Department of Ecology, Central Regional Office (CRO) Response to Facility Comments	
Facility:	Pateros POTW, WA0020559
Name of Document Reviewed	City of Pateros Response to Facility Review of Draft Permit and Fact Sheet
Date of Review	04/02/2025
Reviewer Name and Title	Lucy (Lucila) Cornejo, Permit Developer/Facility Manager

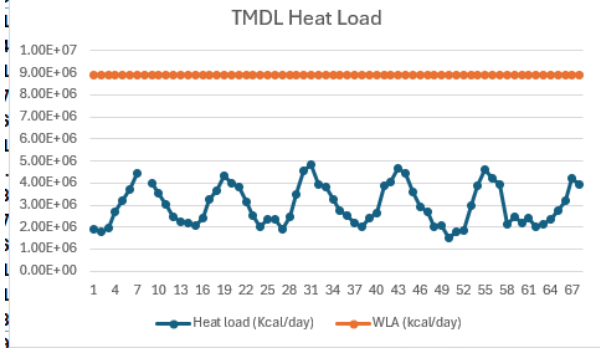
<p>The table above is the calculated heat load value for the past six years from Jan 2019 to August 2024. The heat load was calculated with the average DMR temperature X DMR monthly average MGD X Constant 3.78e+06.</p>
	IV. A. Wastewater monitoring/ Pg 30	<p>1st para – suggest removing ‘for Aeromod ...’. the Permit Writers Manual does not have an Aeromod category for sampling.</p> <p>2nd para – what additional nutrients are you requesting samples for?</p>
Ecology Response		<p>1st para- removed Aeromod.</p> <p>2nd para- language has been removed.</p>
	Other Permit conditions V.B Prevention of Facility overloading/ Pg 30	<p>Last para – looks like the para describing contacting Ecology for funding should be deleted or moved elsewhere.</p>
Ecology Response		<p>Permit shell language.</p>
	V.C. Operation and maintenance/ Pg 32	<p>3rd para about infiltration is outdated and from the 2015 permit. Consider eliminating or revising per the 2025 WWFP.</p> <p>Suggestion for a revision– ‘Pateros POTW has documented infiltration into its collection system. The 2025 WWFP by Varela includes a collection system Capital Improvement Plan</p>
